Groundwater Application Review Summary Form

Application # G- 19328

TO: Water Rights Section Date August 14, 2025
 FROM: Groundwater Section Gabriela Ferreira/Stacey Garrison
 Reviewer's Name
 SUBJECT: Application G- 19328 Supersedes review of December 4, 2023
 Date of Review(s)

A. GENERAL INFORMATION: Applicant's Name: Randy Steffen County: Marion

Well Statistics

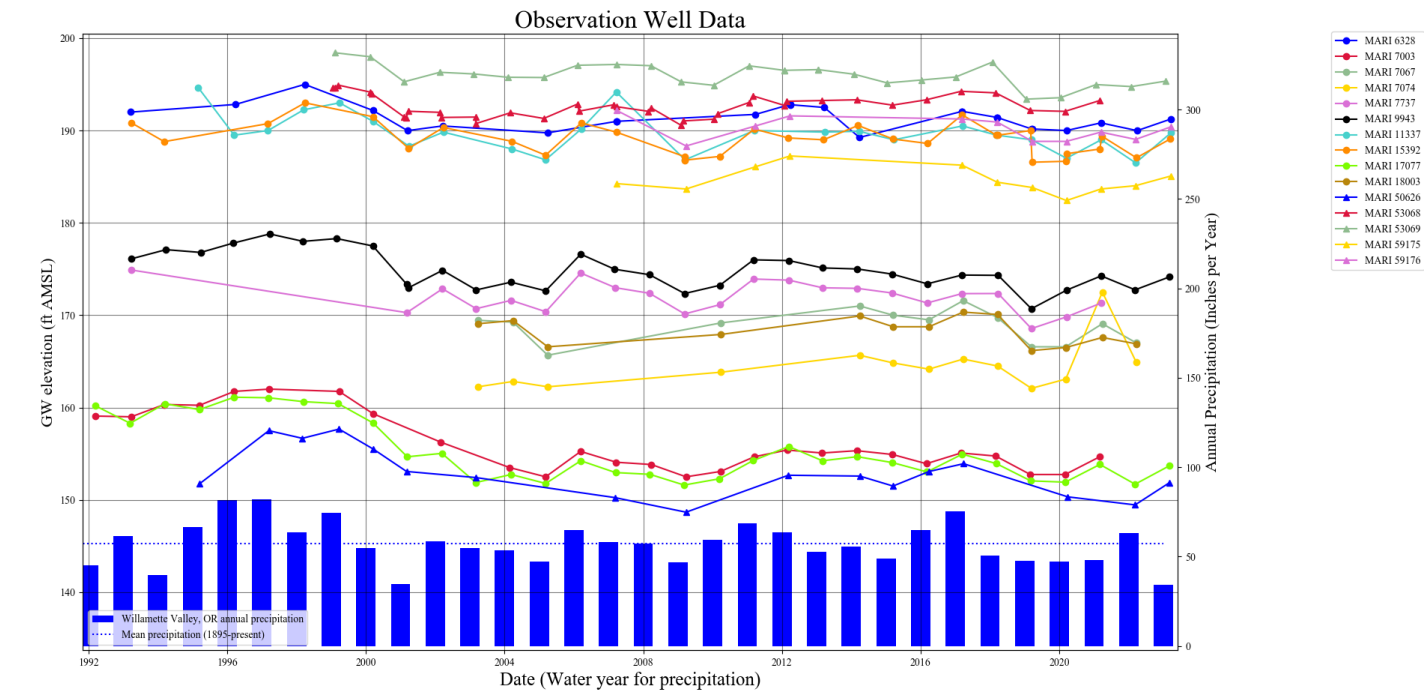
Median yield for nearby wells was 50 gallons per minute and typically ranged from 10 to 200 gpm with a few wells producing 200 to 1200 gpm (see attached well statistics). The reported yield for nearby MARI 7668 was 1000+ gpm by air test in 1978. The requested rate of ~834 gpm is within the upper range of nearby wells.

Theis Interference Analysis

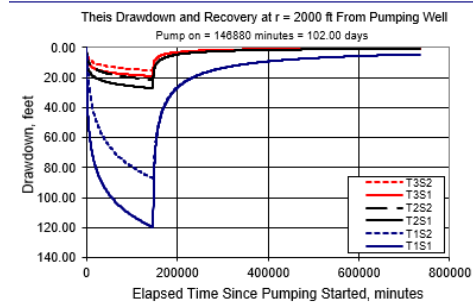
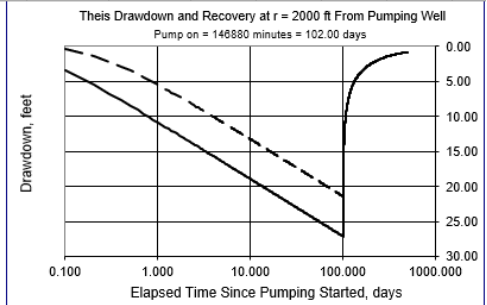
The nearest known CRBG well (MARI 7053) is approximately 2000 feet north of the proposed POA. MARI 7053 is an irrigation well associated with GR Claim 1221 and completed to a depth of 350 feet below land surface (bls). The attached Theis drawdown analysis models potential impacts on MARI 7053 assuming the full duty and rate of the proposed POA. Transmissivity values are based on pump tests from nearby basalt wells. At the lowest observed transmissivity (600 ft²/day), drawdown temporarily exceeds 25 feet; however, drawdown is nearly or less than 25 feet for the median and highest

reviewed transmissivity values. It appears unlikely that interference in excess of the typical permit condition limits (Condition 7i) would occur at MARI 7053 as a result of the requested withdrawal. **In order to protect senior users, Condition 7RLN (Willamette Basalt) is strongly recommended for any permit issued in association with this application.**
